Title			
BLOCK DIAGRAM & PAGE INDEX			
Size	Document Number	Rev	
A2	S15	-1	
Date	Friday, December 12, 2008	Sheet	1 of 50

Wistron Incorporated 21F, 88, Hsin Tai Wu Rd Hsichih, Taipei	
Title REVISION HISTORY	
Size A2	Document Number S15
Date Friday, December 12, 2008	Sheet 2 of 50
Rev -1

Title
POWER VTT 5VDUAL 2P5_MCH

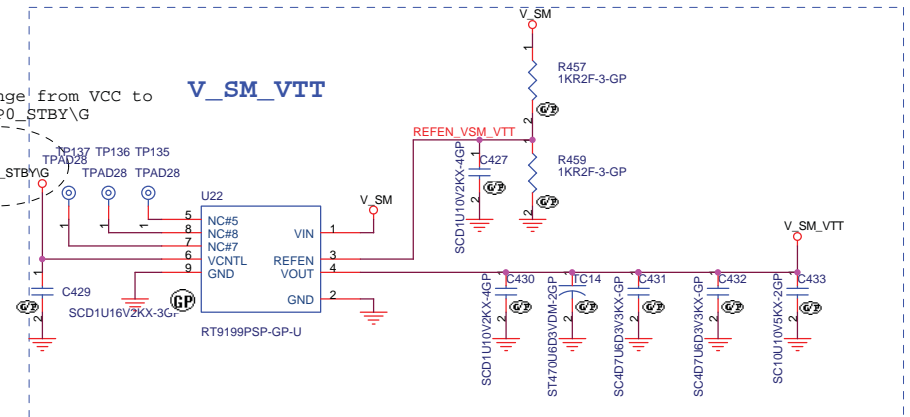
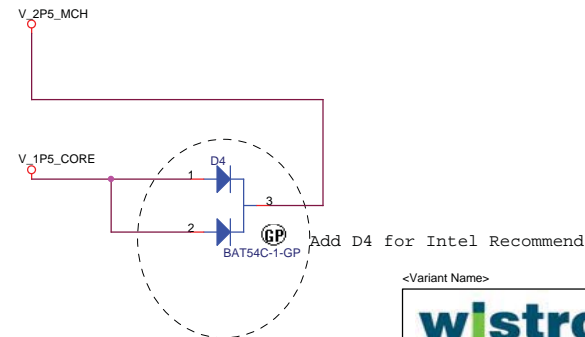
change from VCC to
V_5P0_STBYG

Delete V_5_USB control circuit and
connect to 5VDUAL directly

Wistron Incorporated 21F, 88, Hsin Tai Wu Rd Hsichih, Taipei	
Title GLUE LOGIC 1 OF 3			
Size B	Document Number S15		Rev -1
Date:	Friday, December 12, 2008	Sheet	50 of 50

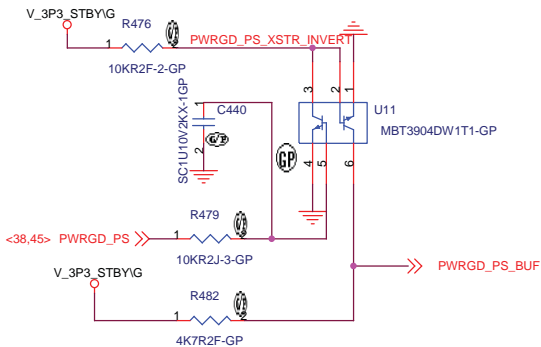
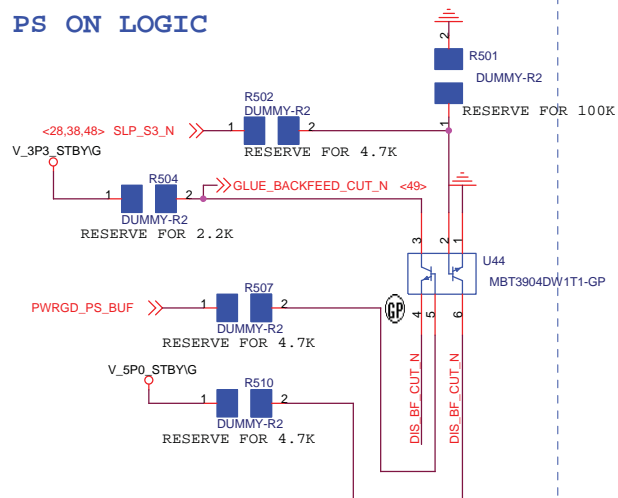
change C439 & R475 power source from VCC to V_5P0_STBY\G

R492,R495,
C444change to
Dummy
